Doran Drive Plaza Precinct

State Significant Development Assessment
SSD-15882721

July 2022

Construction of a 20-storey mixed-use development, comprising retail, commercial and community spaces, 430 residential units and a public plaza.

Figure 16 | Illustration demonstrating the amended proposal complies with the approved building envelope. (Source: RtS)

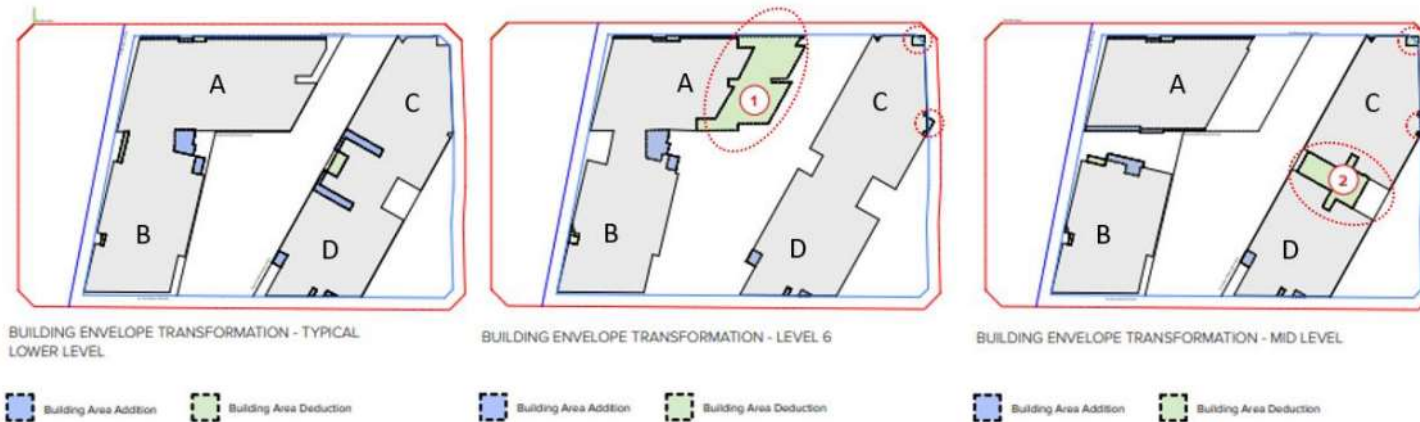
With RtS submission, the Applicant amended the proposal by removing two levels from the eastern end of Building A and seven levels between Buildings C and D (represented as 1 and 2 respectively in *Figure 16*). The Applicant also removed all balconies and architectural elements which projected beyond the approved building envelope.

The Department accepts the amended proposal (RtS)

- complies with the Hills LEP, having a maximum building height of 68 m and an FSR of 3.2:1 (maximum 4:1)
- complies with the Concept Approval, as it is fully contained within the approved building envelopes, has a maximum GFA of 51,065 m² and accommodates 430 dwellings
- complies with the UDG, which is aimed at providing built forms that are compatible with the desired character of the area.

Figure 26 | Building separation across podium communal open space (above) and visual privacy between internal elevations of Building A and Building B (below left) and between Building C and D (below right) (Source: RtS)

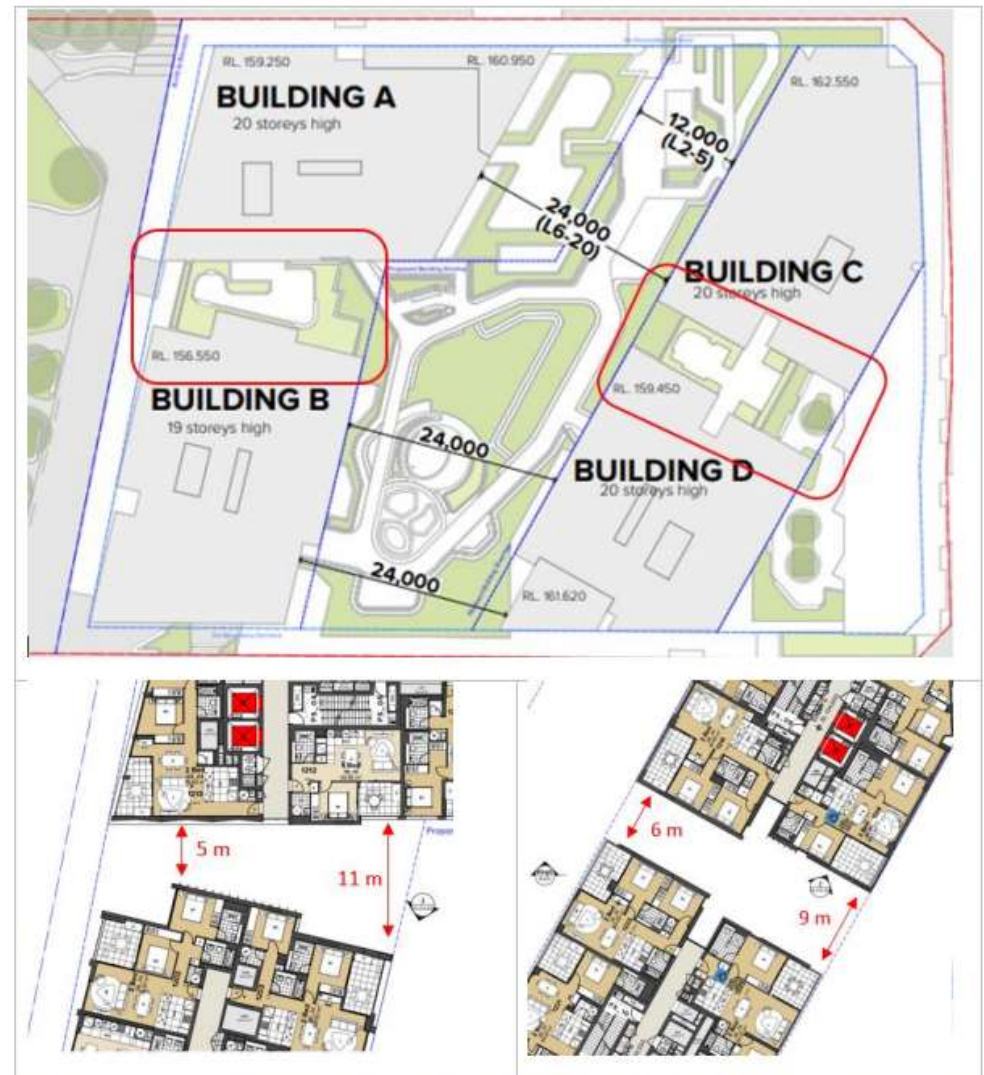
The Department notes the proposed buildings have a 24 m building separation across the communal open space above the podium in accordance with the ADG requirements. However, the proposed building separation is less than 12 m between the internal elevations of Buildings A and B and Buildings C and D (Figure 26)

The Department has carefully considered the amenity and privacy outcomes of the proposed dwellings and is satisfied the proposed building separation is acceptable in this case because the separations between the towers are intended to mitigate the visual bulk and scale of the buildings and are not relied upon for outlook or primary light and ventilation for the dwelling.

Figure 22 | Approved street and tower setbacks (Source: Concept Approval)

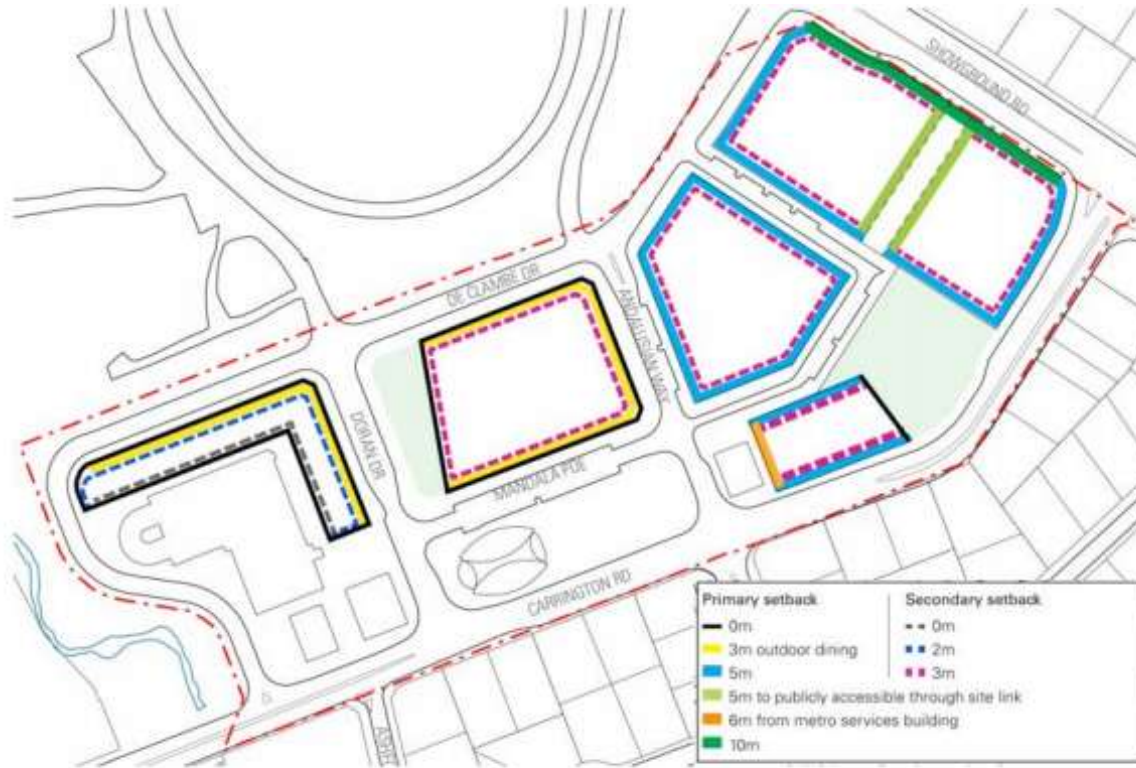
In response to the concerns raised about the primary setbacks, the Applicant amended the primary setbacks to comply with the THLEP and align with THDCP.

- from 3 m to 10 m along Showground Road
- from 3 m to 5 m along the new internal road
- from 4.5 m to 5 m along Carrington Road.

The Department accepts the amended proposal now complies with the primary setback development standard in THLEP, noting the increased setback:

Figure 18 | Building separation between the three precincts (Base source: RtS)

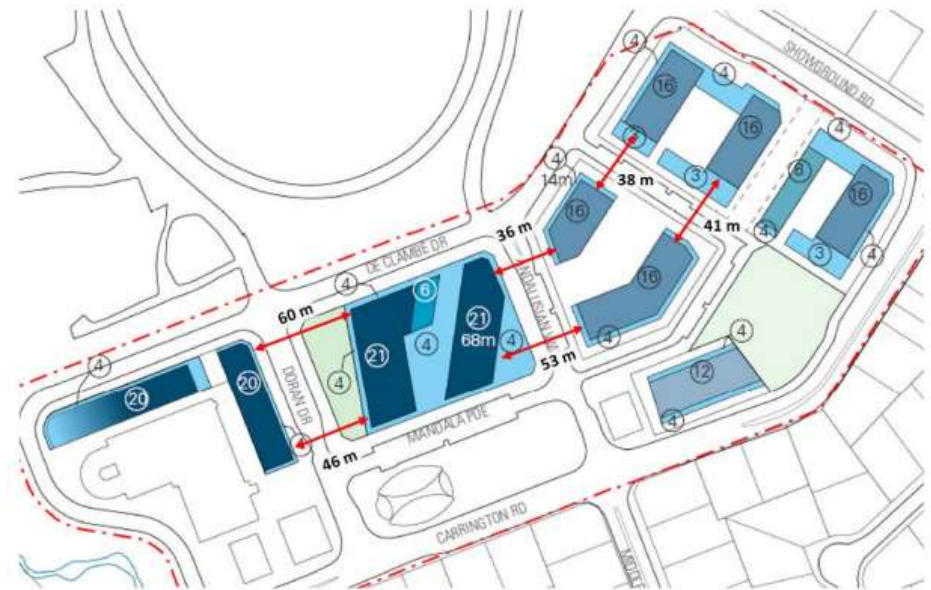
Whilst the proposed secondary setbacks are less than those envisaged in THDCP, the Department considers the proposal would still achieve these objectives because separation distance between the towers exceed that envisaged under the THDCP setback controls (**Figure 18**). This is due to:

- the THDCP setback controls envisaged a secondary setback from Doran Drive without taking into account the location of the proposed Doran Drive Plaza that will provide a building separation of 46 m to 60 m between towers facing Doran Drive
- the proposed tallest towers (up to 68 m tall) in the Doran Drive Precinct are angled from the street alignment and orientated away from their street frontage
- the proposed 3 storey building envelopes in Precinct East would provide additional separation between the proposed 16 storey buildings.

Figure 20 | Vehicular access points (Source: RtS)

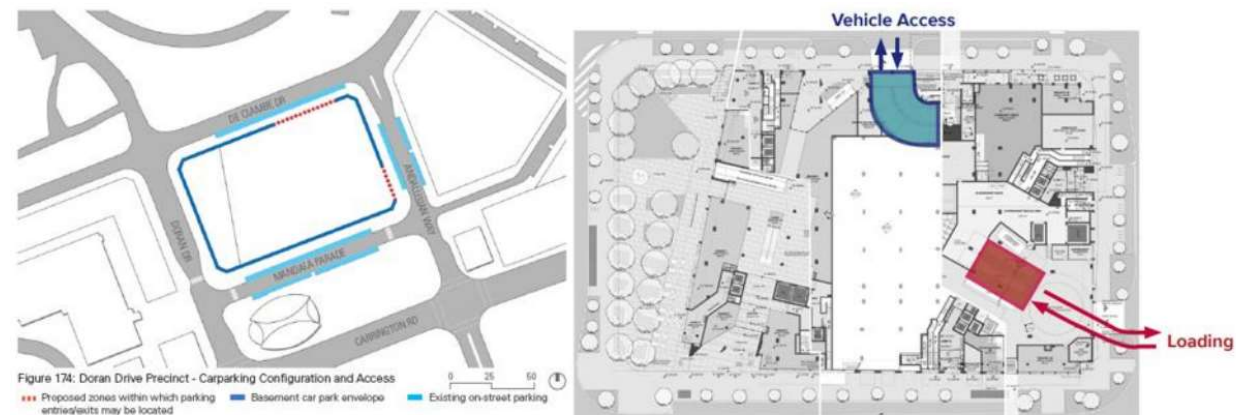
The Department considers the amended proposal provides appropriate design and management measures for loading and servicing noting:

- concerns raised by Council and SINSW have been satisfactorily addressed
- the turntable and on-site loading dock manager will manage the daily operation of the loading dock
- appropriate conditions are recommended to mitigate conflicts between pedestrians and truck and between residential and commercial waste arrangements (Condition E32)
